Advisory Plan Commission

Town of Brownsburg

Request Type: Development Plan Review

CASE NUMBER	PSDP-26-3
APPLICANT	Kevin Steely, Terra Site Development Inc.
LOCATION	32- 08-29-200-020.000-016
PARCEL SIZE	7.5 acres

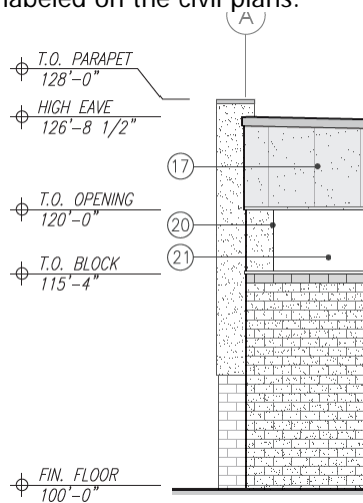
- a) The project's lot coverage is 64.52% which is lower than the max allowed 70%. The architectural details submittal lists the highest point on the building (top of parapet) as being 128' tall. The max height allowed for a primary structure in an I2 district is 65'. The entry doors are marked on the elevations as being 7' tall and the building appears to be 3.5 doors tall which would come out to 24.5', not 128'. This leads staff to believe this is just a typo and the accurate numbers will

need to be put on the architectural details submittal. There are also two South elevations marked, the loading dock side needs the label changed to 'North Elevation'. Setbacks are correct and labeled on the civil plans.

<input type="checkbox"/>	Approve PSDP-26-3 as presented.
<input checked="" type="checkbox"/>	Approve PSDP-26-3 with the following staff conditions: <ol style="list-style-type: none"> 1. The completion of outstanding TECH comments. 2. The approval of a final plat that shall be recorded in the Office of the Recorder of Hendricks County prior to issuance of any building permits. 3. The approval of the Finding of Fact and Report of Determination by the Plan Commission. 4. Accurate building height labels need put on the architectural details and the loading dock elevation should say 'North Elevation' instead of having two South elevations shown.
<input type="checkbox"/>	Deny PSDP-26-3 based on the following criteria:
